Response to Written Comments due by March 13, 2015:

RE: IRP Manager (and Select CAC Comments) Regarding the California Regional Water Quality Control Board Lahontan Region Cleanup and Abatement Order (CAO) No. R6V-2015-Prop, Issued on January 21, 2015.

² California Regional Water Quality Control Board, Lahontan Region. 2015. *Cleanup and Abatement Order [Proposed] No.R6V-2015-Prop WDID No.6B369107001, Requiring Pacific Gas and Electric Company to Clean up and Abate Waste Discharges of Total and Hexavalent Chromium to the Groundwaters of the Mojave Hydrologic Unit*. January 21.

FIGURE 3

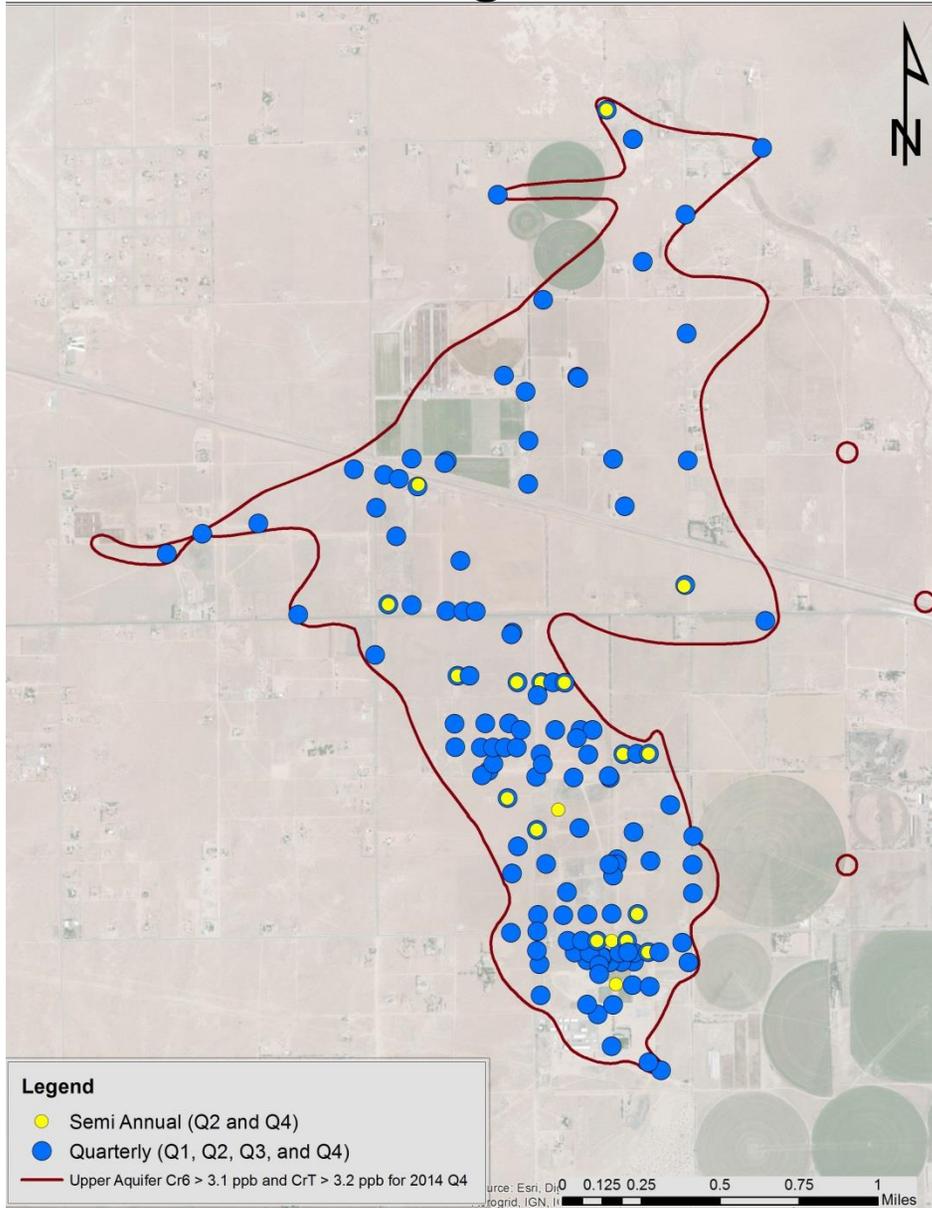
- Clarification sought on section C.1.b. *“Semi-annual sampling in the second and fourth quarter of each year at multi-depth monitoring wells showing the second **and third** highest hexavalent or total chromium detection above maximum background levels as of fourth quarter 2014.”* Do the words *“and third”* require to be deleted in section C.1.b since section C.1.c. discusses “the third highest hexavalent detections”?

Figures 3 to 6 describe the IRP Manager's interpretation of the Water Board's proposed monitoring well sampling program for the southern plume area. **Figure 3** shows the monitoring wells that fall under requirements I.C.1 in the MRP for monitoring wells greater than or equal to maximum values as of the fourth quarter, 2014. A total of **170 monitoring wells** fall into this category and consist of **132 quarterly** and **38 semi-annual** monitoring wells. **Figure 4** shows monitoring wells that fall under requirements I.C.2 for wells with concentrations less than maximum background values as of fourth-quarter, 2014. A total of **132 monitoring wells** fall into this category, consisting of **30 quarterly** and **102**

FIGURE 5

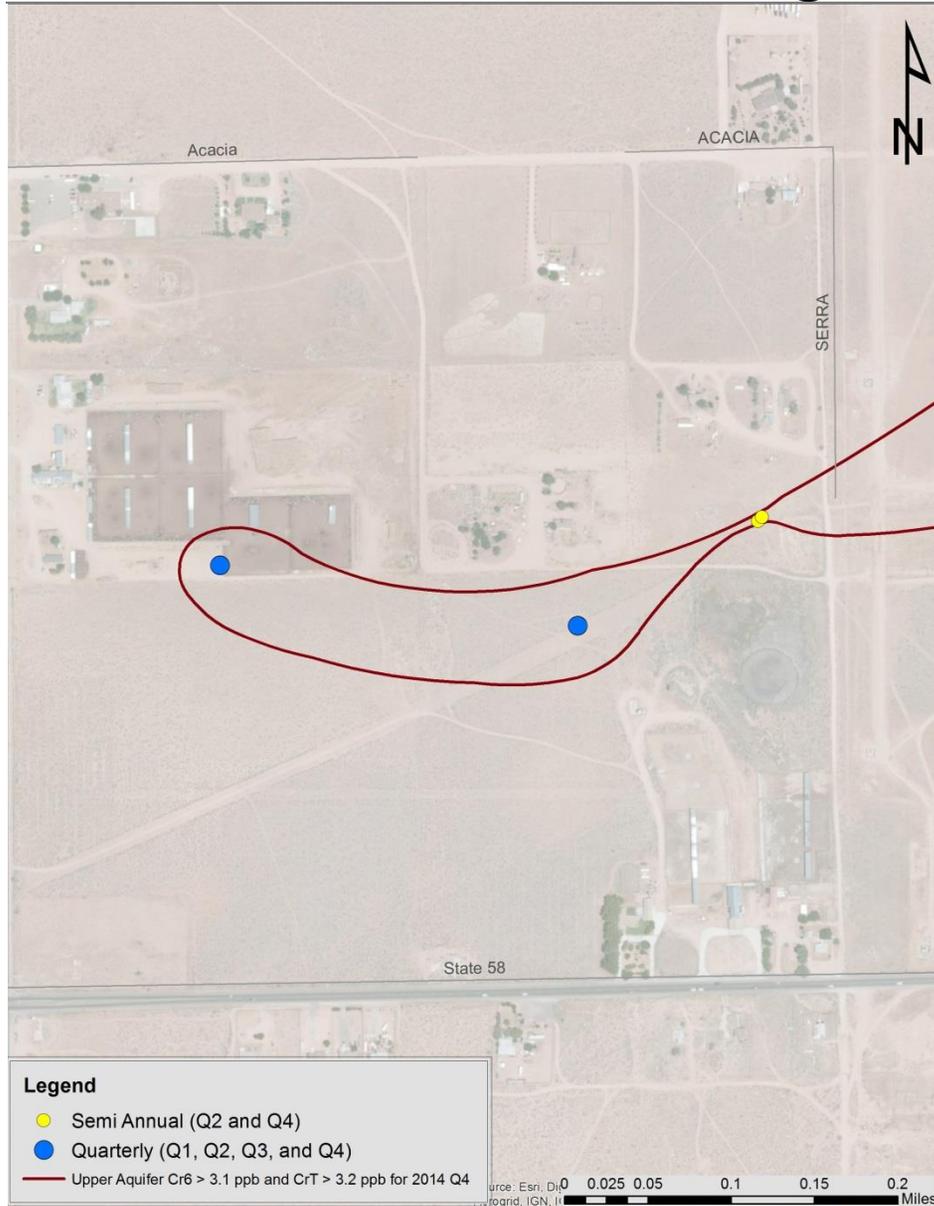
Figure 5 shows monitoring wells under requirement I.C.3 for the “Western Finger” located west of Serra Road. **7 monitoring wells** fall under this category consisting of **2 quarterly, 2 semi-annual** and **3 annual monitoring wells**.

FIGURE 6

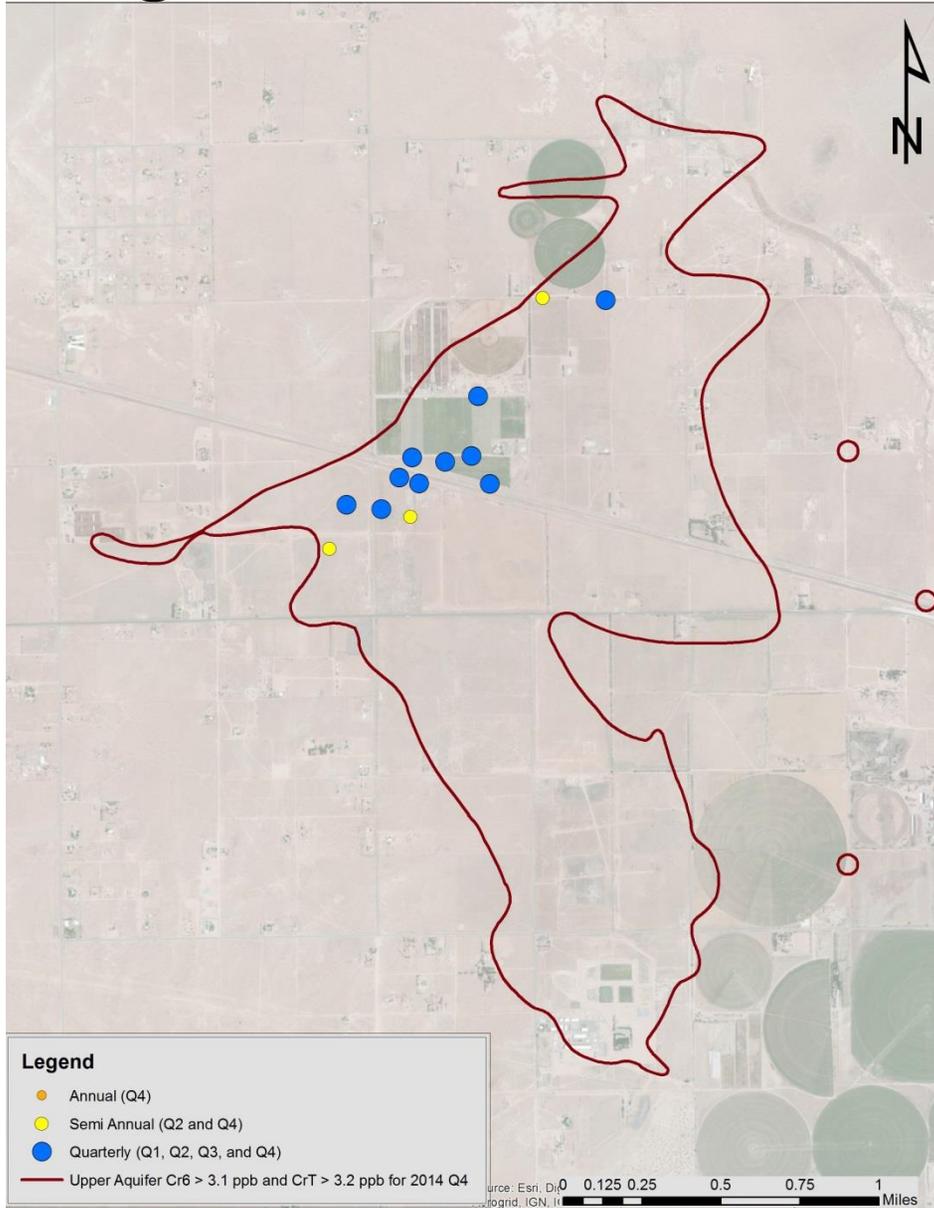
Figure 6 shows the monitoring requirements for the lower aquifer in accordance with I.C.4. A total of **13 monitoring wells** are included, consisting of **10 quarterly** and **3 semi-annual** monitoring wells. These maps, prepared by the IRP Manager's staff indicate that the southern plume will be comprehensively monitored via the Water Board's proposed monitoring plan.

FIGURE 7

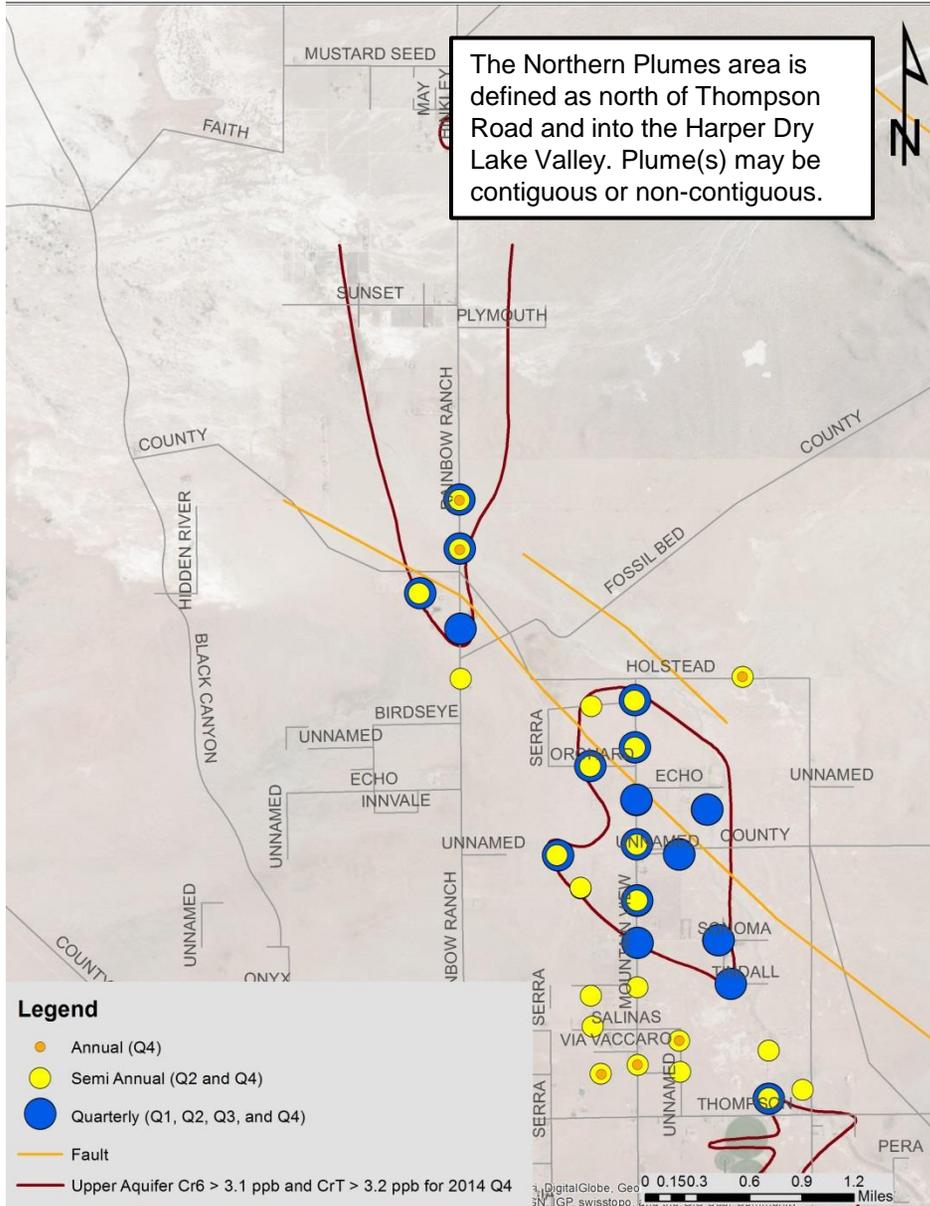
- What is the minimum sampling frequency for monitoring wells in the northern plume area?;
- What is the general sampling reduction plan for monitoring wells discussed in Section I.D.4 (e.g. quarterly → semi-annual → annual)?;

Figure 7 shows the IRP Manager's interpretation of the sampling program in the Northern Plume(s) Area.

FIGURE 8

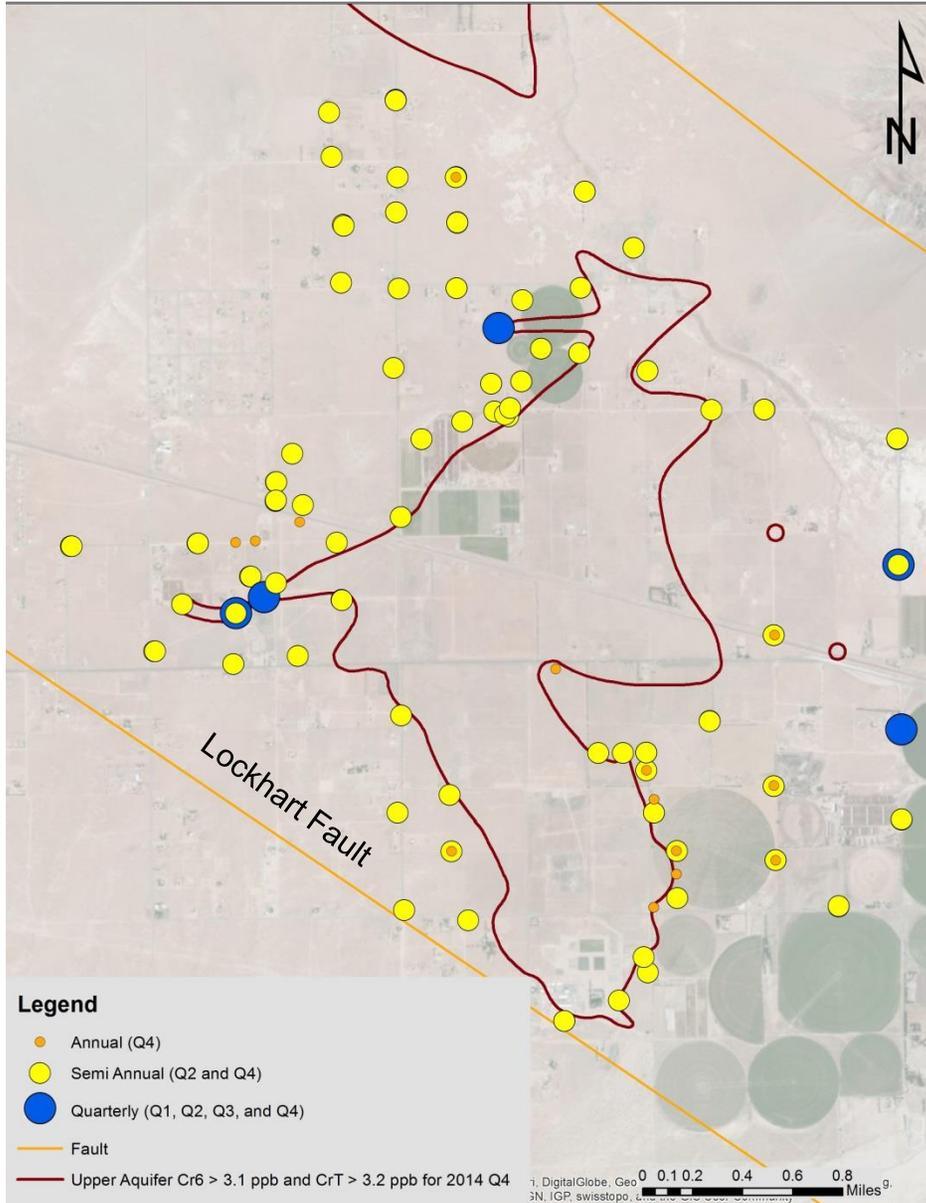
Figure 8 shows the monitoring wells that are under requirement I.E. Under I.E there are **161 monitoring wells**. They consist of **5 quarterly, 128 semi-annual** and **28 annual** monitoring wells. Our suggestions regarding

Section I.E is that statistical trends (e.g. Mann-Kendall test) should be a component to determine the sampling frequency in this area.

FIGURE 10

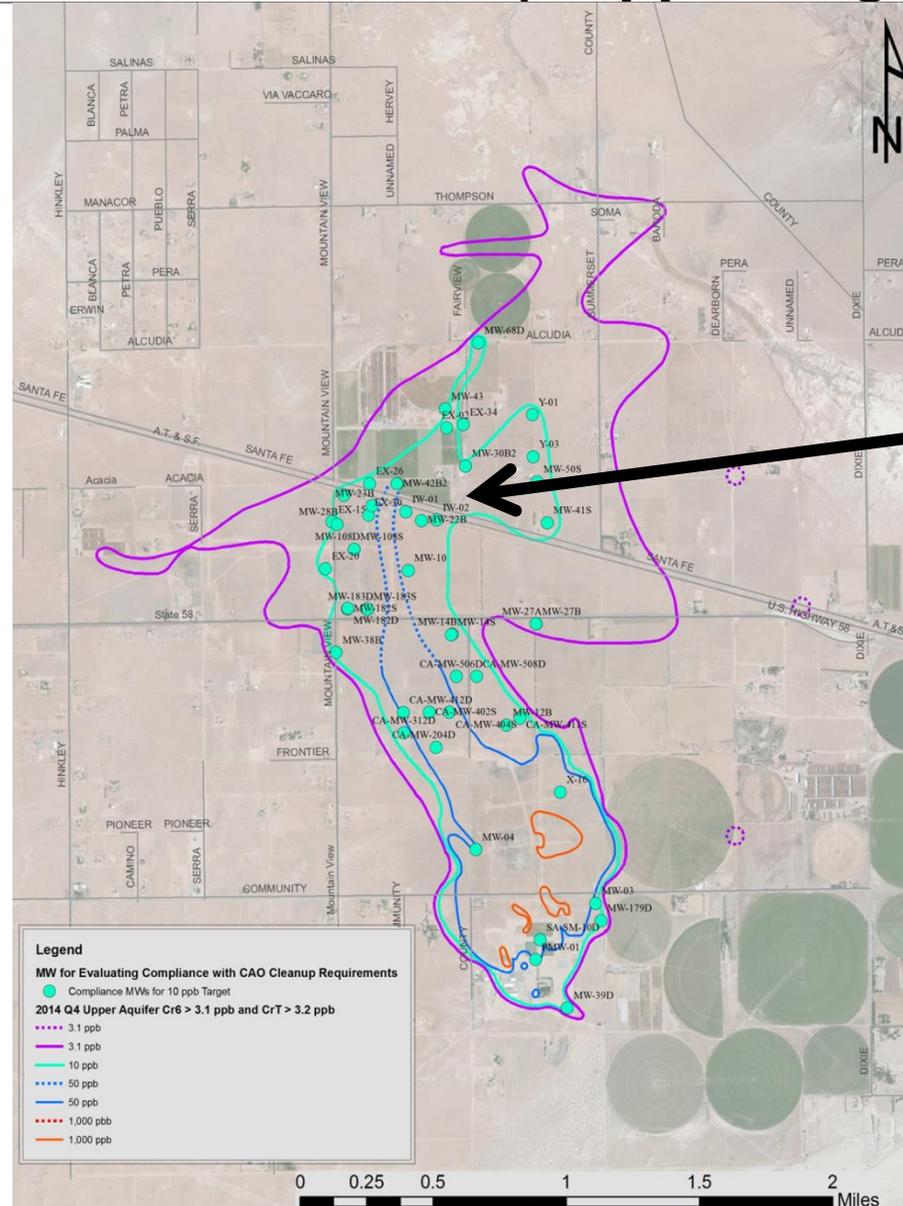
- On page 11 of the MRP, the Cr (VI) and Cr (T) values for DMW-03 are 320 ppb and 360 ppb, respectively. The well associated with this data for the Third Quarter 2014 is PMW-03, and not DMW-03.
- **Figures 10 and 11** are the IRP Manager's interpretations of the Water Board's monitoring wells for evaluating compliance with the CAO cleanup requirements for the Southern Plume to the 10 ppb and 50 ppb targets.
